MECKLENBURG COUNTY
Health Department

Re: Application for improvement permit for: 4 Bedroom House
Property Location: 2775 Kelly Rd, Charlotte, NC 28216
Health Department File Number: **6746 (App ID 8332)**

SOIL/SITE EVALUATION for ON-SITE WASTEWATER SYSTEM

Sketch of Soil Evaluation Locations

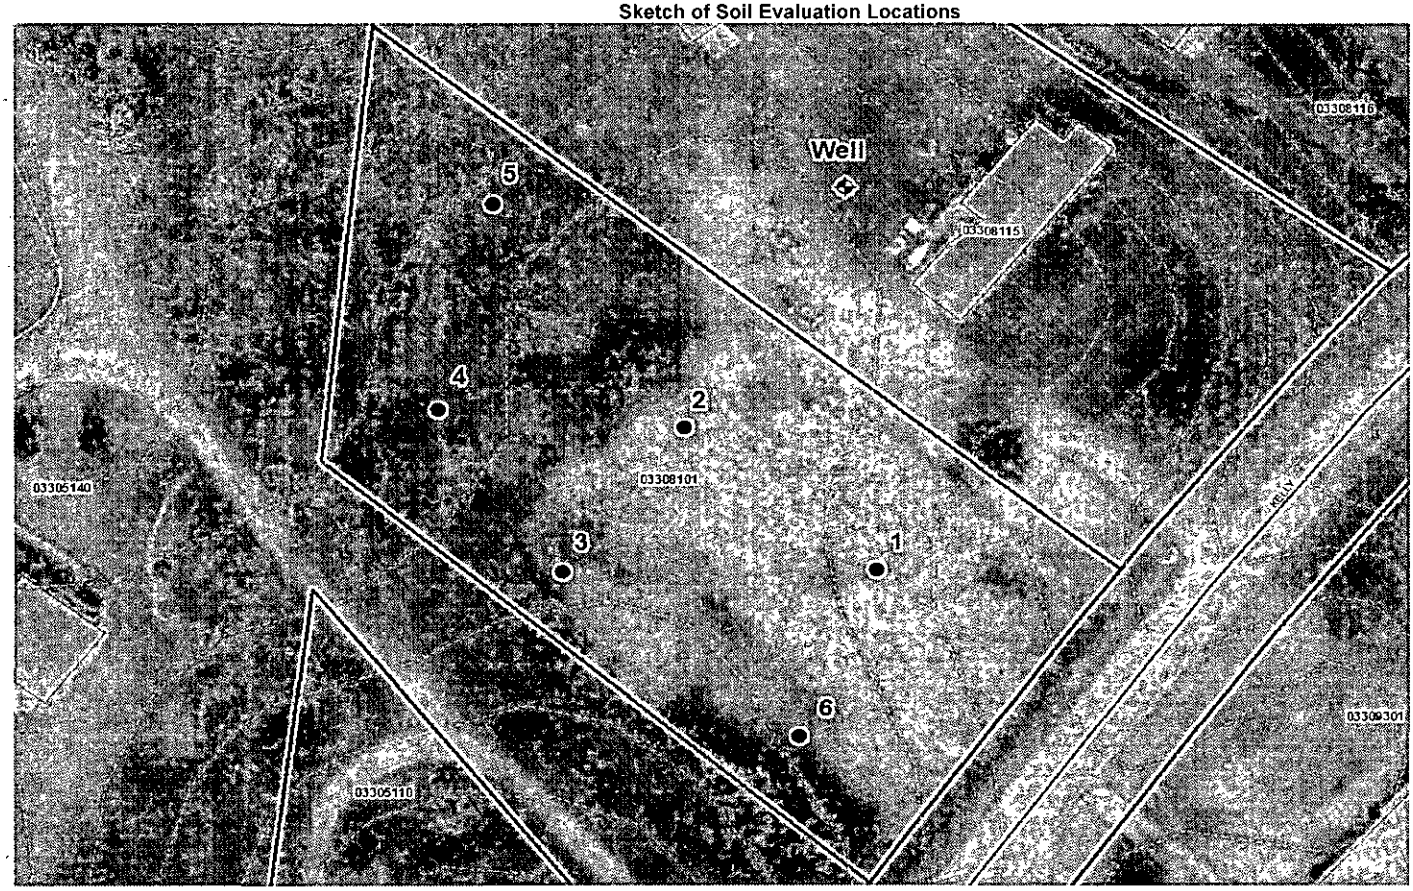
PROFILE #	.1940 Landscape Position/ Slope%	Horizon Depth (IN.)	SOIL MORPHOLOGY (.1941) .1941 Structure/ Texture	.1941 Consistence Mineralogy	b PROFILE FACTORS .1942 Soil Wetness/ Color	.1943 Soil Depth (IN.)	.1956 Sapro Class	.1944 Restr Horiz	General Comments	Profile Class & LTAR	Maximum Trench Bottom Depth for 3' Wide Conventional Trench
Boring #1	HS 4%	0 - 14	gr SL	SS SP FR SEXP	2 chroma at 18"	14	NA	NA		US	NA
		14 - 25	mass SCL	S SP VFI EXP							
Boring #2	R 2%	0 - 11	gr SL	SS SP FR SEXP	2 chroma at 22"	11	NA	NA	saprolite inclusions 15 - 30"	US	NA
		11 - 30	mass C	S P VFI EXP							
		30	Grinding on Rock and Saprolite								
Boring #3	R 2%	0 - 10	sbk CL	SS SP FR SEXP	2 chroma at 17"	10	NA	NA		US	NA
		10 - 18	mass SCL	S SP VFI EXP							
		18 - 32	mass C	S VP VFI EXP							
Boring #4	R 2%	0 - 10	gr SL	SS SP FR SEXP	2 chroma at 23"	10	NA	NA	saprolite inclusions 20 - 32"	US	NA
		10 - 20	mass SCL	S SP VFI EXP

20 - 32	mass C	S P VFI EXP							
Boring #5	SS 5%	0 - 5	gr SL	SS SP FR SEXP	>30"	5	NA	NA	saprolite inclusions 10 - 30"	US	NA
		5 - 10	mass SCL	S SP VFI EXP							
		10 - 20	mass C	S P VFI EXP							
		20 - 30	mass SCL	S SP VFI EXP							
		30	Grinding on Rock and Saprolite								
Boring #6	R 2%	0 - 8	gr SCL	SS SP FR SEXP	2 chroma at 16"	14	NA	NA	saprolite inclusions 14 - 25"	US	NA
		8 - 14	sbk SCL	SS SP FR SEXP							
		14 - 25	mass C	S P VFI EXP

Description	Initial System	Repair System
Available Space (.1945)	US	US
System Type(s)		
Site LTAR (gpd/sq ft)	**US**	**US**

Other Factors (.1946):
Soil Evaluation By: Jacob Presley, LSS, REHS
Others Present:
Site Classification (.1948): Unsuitable
Site Evaluation By: Jacob Presley, LSS, REHS
Others Present:
